FINAL
ENVIRONMENTAL IMPACT STATEMENT

**F-15E BEDDOWN AT SEYMOUR JOHNSON AFB,
NORTH CAROLINA**

- (a) Responsible Agency: United States Air Force
- (b) Proposed Action: Conversion of F-4 to F-15E aircraft that will be equipped with the new Low Altitude Navigation and Targeting Infrared for Night (LANTIRN) system at Seymour Johnson AFB, Wayne County, North Carolina.

- (c) Responsible Individual: Alton Chavis, HQ TAC/DEEV, Langley AFB, VA 23665-5542; Telephone (804) 764-7844.
- (d) Designation: Final Environmental Impact Statement (FEIS).

FIGURE 4.2-1
PROPOSED ACTION
NOISE MAP-BASE

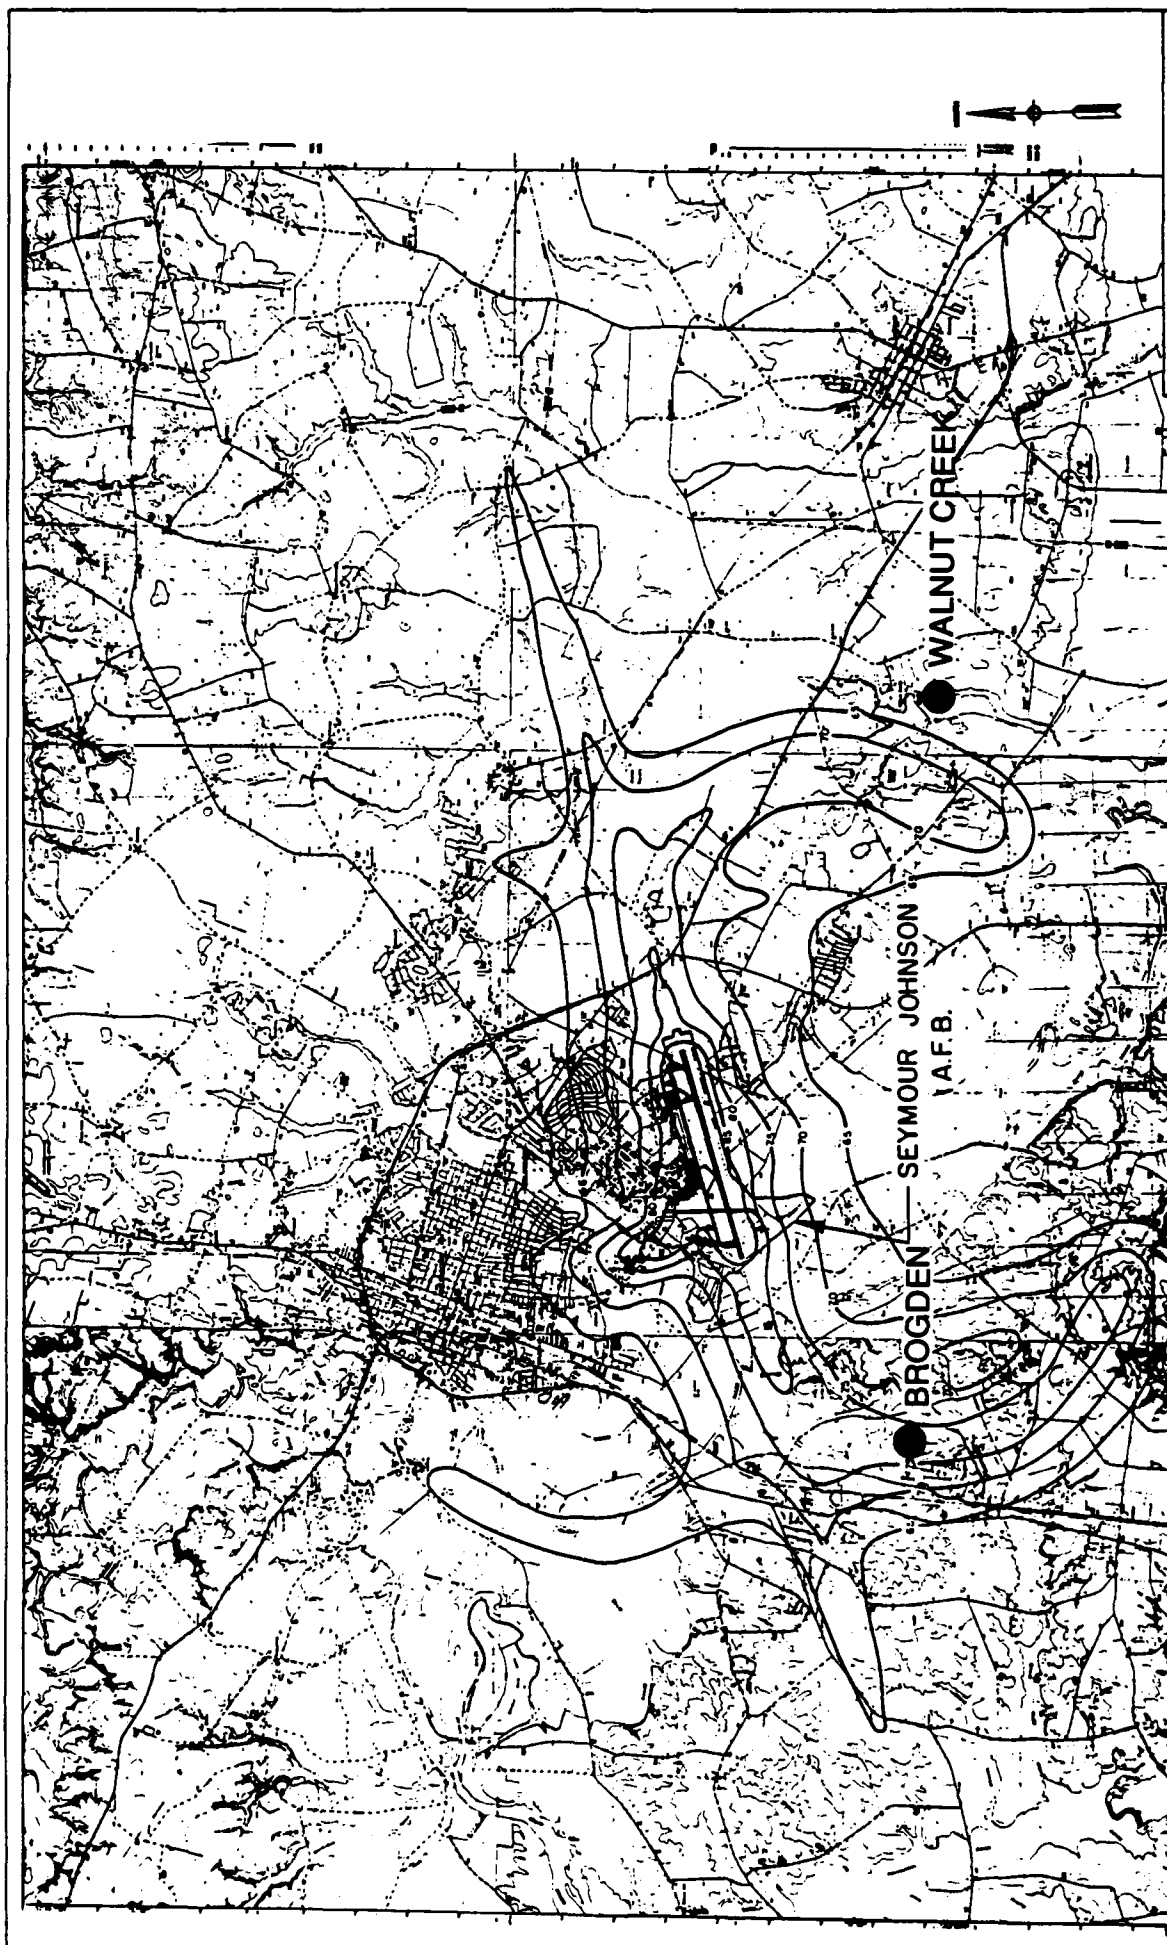
7. In line with comment 4, Figure 3.2-2 only provides a benchmark for showing the noise contours during the 1983 time period. To gauge the short term impacts, the reader should compare Figures 3.2-3 and 4.2-1 which are comparably scaled. Brogden and Walnut Creek have been identified on the maps which are provided in the errata section of this document. Tables 4.7-3 and 4.7-4 both represent "worst case"; the change in the noise level column represents the difference between a value of 55 DNL or the comparable compatible use district (CUD) from Figure 3.2-3. (if the area in question is within the AIC/JZ), respectively.

18. p. 3.4-12, 3rd paragraph, last line: Change Figure 3.0-1 to 3.0-2.
19. p. 4.2-2, Figure 4.2-1: See revised Figure in this section.
20. p. 4.2-4, 2nd paragraph, 3rd line: Change 38 to 14.
